# TOWN OF WELLS, MAINE STAFF REVIEW COMMITTEE

## Meeting Agenda

Tuesday, May 10, 2016, 9:00 AM

Steve & Lisa Duplisea, owner/applicant; Geoffrey Aleva, Civil Consultants, agent. Site Plan Amendment Application to eliminate the previously approved 40' x 100' 2-story office building and 32' x 38' garage and instead construct a 1,792 SF Business Office use (2-story building) and a 1,536 SF Business Contractor/ Business Wholesale/ Warehousing (1-story building), an accessory outdoor storage area/ display area, and associated parking. The parcel is located within the Light Industrial District and is off of 632 North Berwick Road. Tax Map 40, Lot 3-4. **Workshop completeness, compliance and draft Findings of Fact & Decisions for possible approval**

SHEET: 2 OF 2

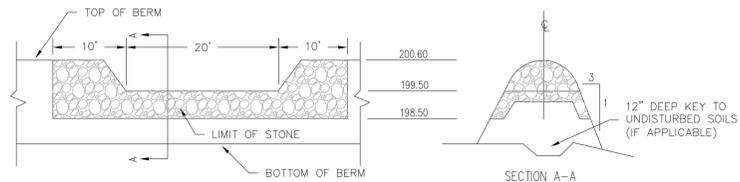
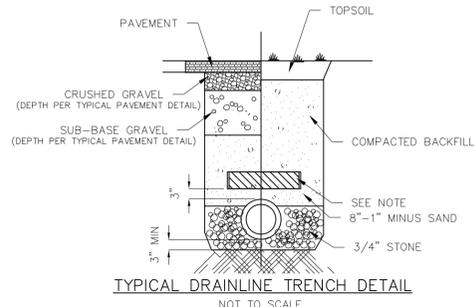
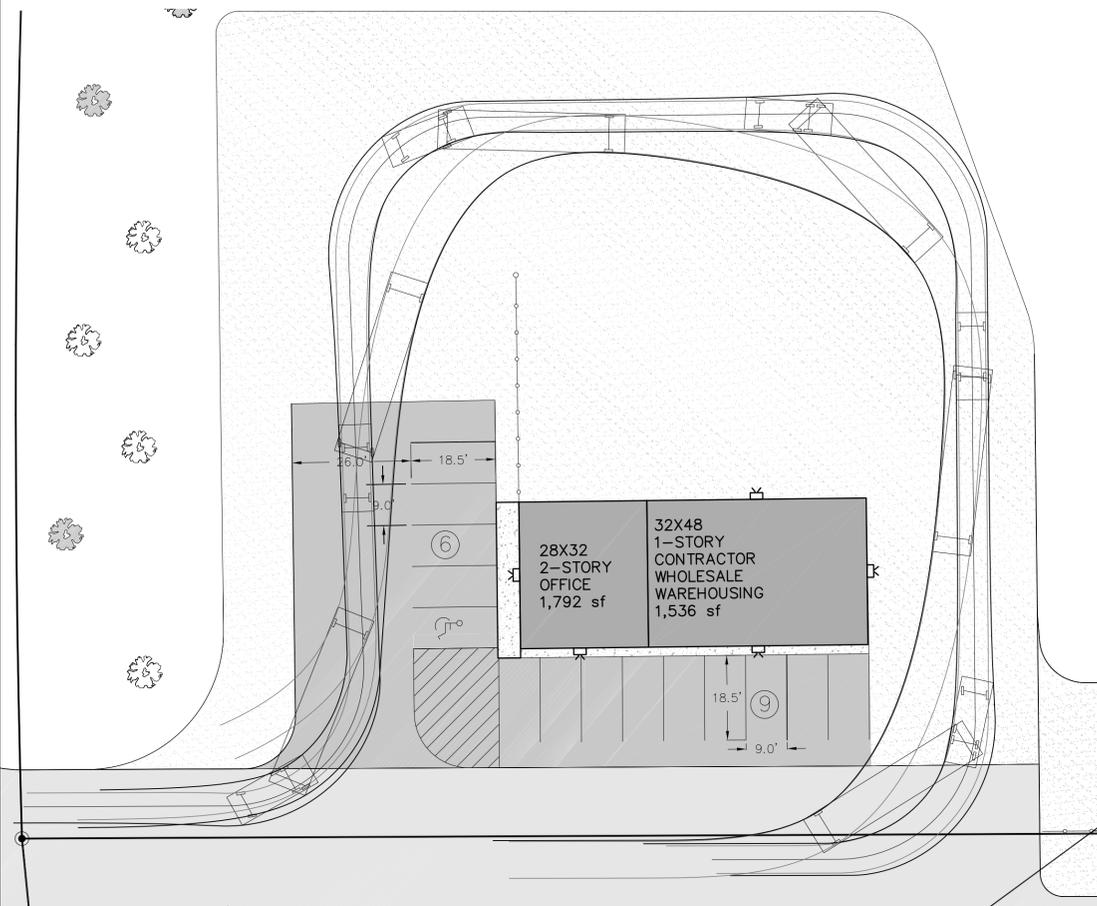
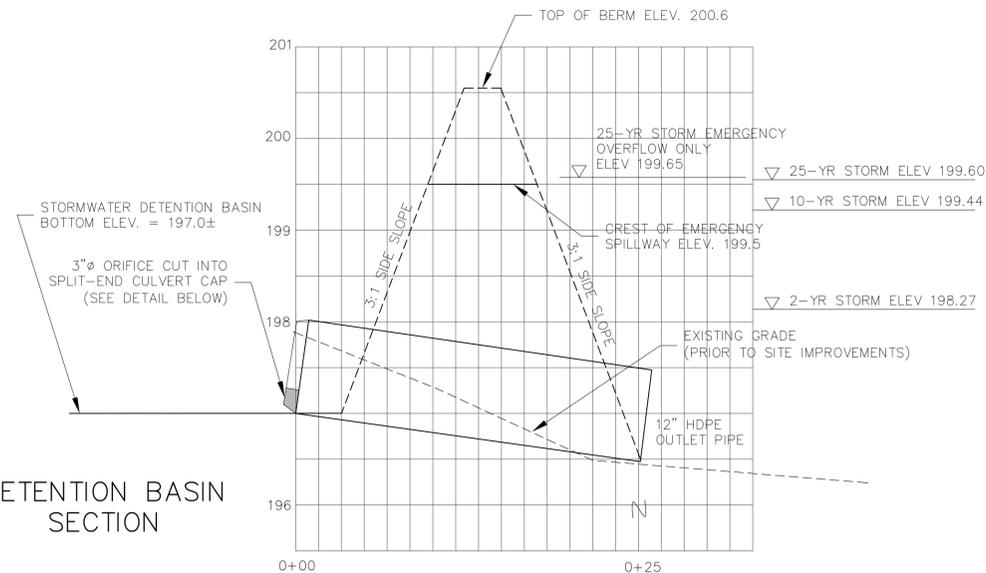
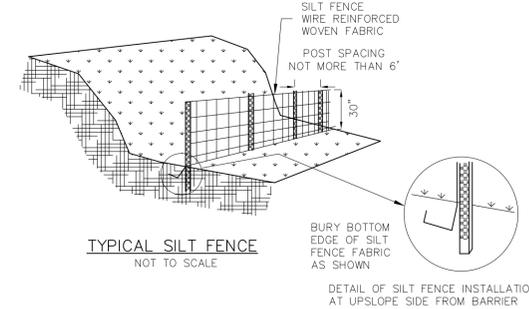
Good : *Additional details needed (sheet L2) - Vegetated swale, Berm section with top elevation and width, rip rap apron for existing culvert extension and in front of 3" orifice, emergency spillway/weir, 3" orifice/cap*

6. It was requested that the following details be added to sheet L2: vegetated swale, berm section indicating top elevation, rip rap apron detail, 3” orifice/cap detail, and emergency spillway/weir detail.

*The details for the vegetated swale, berm section, 3” orifice/cap, and emergency spillway/weir have been added to sheet L2. The berm section also indicates the predicted water levels at the various storm events, including the 25-yr event with the 3” orifice blocked.*

*The stone lined plunge pool detail is intended to be utilized at both culvert outlets and will be used in lieu of a rip rap apron detail.*
